ITEM V-C: **GENERAL PLAN AMENDMENT, REZONE, DEVELOPMENT AGREEMENT AMENDMENT, DESIGN REVIEW PERMIT, & TENTATIVE SUBDIVISION MAP – 1490 BLUE OAKS BOULEVARD (BLUE OAKS OFFICE AND RETAIL) -- FILE#S GPA 05-02, RZ 05-02, DAA 05-04, DRP 05-19, and PM 05-03.**

REQUEST

Figure 1: Option A

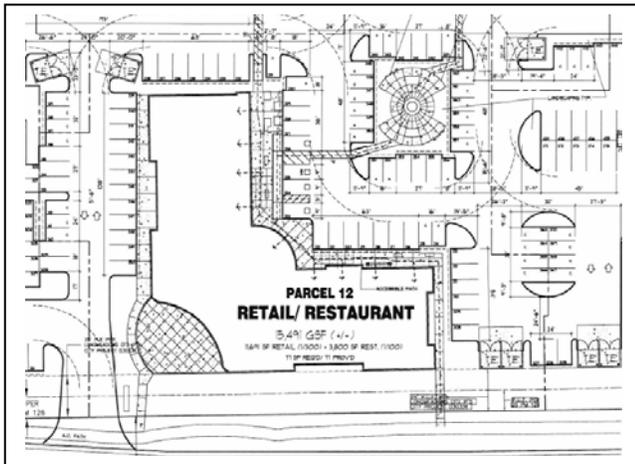
To present the Commission with alternative site designs to consider, staff had requested that the applicant explore other site plan configurations that would reorient the fast food/gas station and canopy more centrally on the parcel. One option that staff had suggested included shifting the restaurant and retail buildings (or the drug store building presented in Option B) on Parcels 11 and 12 toward the west and moving the fast food and gas station to the current location of the retail building on Parcel 11. This option would place either the "L"-shaped or drug store buildings on the corner, both of which provide a more suitable interface with the intersection.

- As noted in the Rezone evaluation above, this area is a gateway into the North Roseville Specific Plan. Given the visibility of this intersection, a fast food restaurant and gas station should not be the defining architectural statement at this corner. While the fast food building does incorporate some of the architectural treatments of the rest of the center, the building's massing will not contribute to the streetscape presence already established by the Crocker Ranch Center.

- **Modified Condition 3a:** *The Fuel Station and canopy shall be relocated from the corner of Blue Oaks and Woodcreek Oaks Boulevards to the location of Parcel 11. The retail/restaurant building on Parcel 12 shall be located at the corner of Blue Oaks and Woodcreek Oaks Boulevards, as suggested in Attachment 7.*
